Minutes of the Regular Meeting of the Public Building and Site Commission held on Tuesday, August 22, 2017 at the Reed Intermediate School. Chairman Robert Mitchell called the meeting to order at 7:09 p.m.

**Monthly Report  
to the Public Building and Site Commission  
August 22, 2017**

# Newtown High School Auditorium Renovations State Project #097-CPPP

## SIGNAGE SUBMITTAL

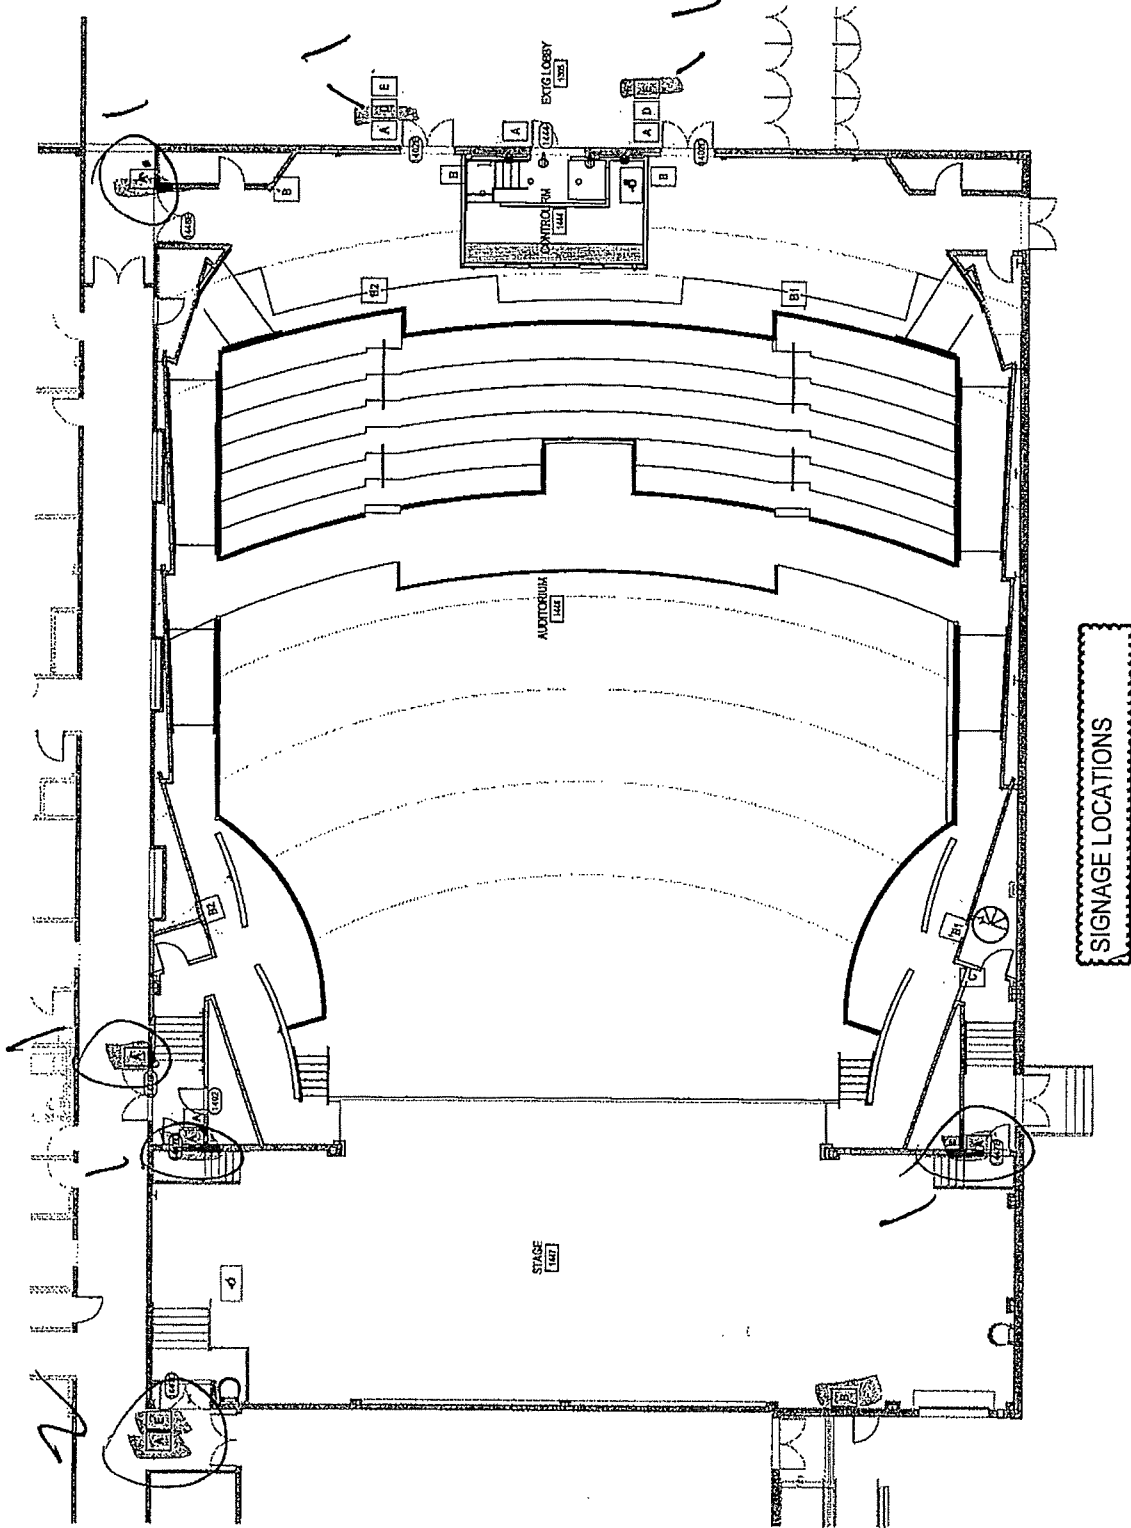
- PLEASE PROVIDE QUANTITY AND LOCATION OF ALL TYPE B SIGNS REQUIRED AS REQUESTED IN RFI #49.

Door#	Type	Copy
1402	~A	AV ROOM
1402D	~A	<del>1305 LOBBY</del> AUDITORIUM
1402D	~D	ASSISTED LISTENING (Ear pictogram)
1402E	~A	<del>1305 LOBBY</del> AUDITORIUM
1402E	E	OCCUPANT LOAD ??? PERSONS By Order of the Code Official MAXIMUM OCCUPANCY
1403	G	CATWALK ACCESS 925
1404	~C	CATWALK ACCESS
1444	~A	1444 CONTROL ROOM
?	B	(Accessible pictogram) EXIT (SEE ATTACHED)
?	B1	(Accessible pictogram, arrow left) RAMP ACCESS (SEE ATTACHED)
?	B2	(Accessible pictogram, arrow right) RAMP ACCESS (SEE ATTACHED)
1402E	~D	ASSISTIVE LISTENING (Ear Pictogram)
1402D	E	MAXIMUM OCCUPANCY 925
1447C	E	MAXIMUM OCCUPANCY 214
1447C	~A	STAGE
1447D	~A	STAGE
1447E	~A	STAGE
1446E	~A	AUDITORIUM
1446F	~A	AUDITORIUM

☐ NO EXCEPTION TAKEN ☒ REVISE AND RESUBMIT  
☐ MAKE CORRECTIONS NOTED ☐ EXCEPTION TAKEN
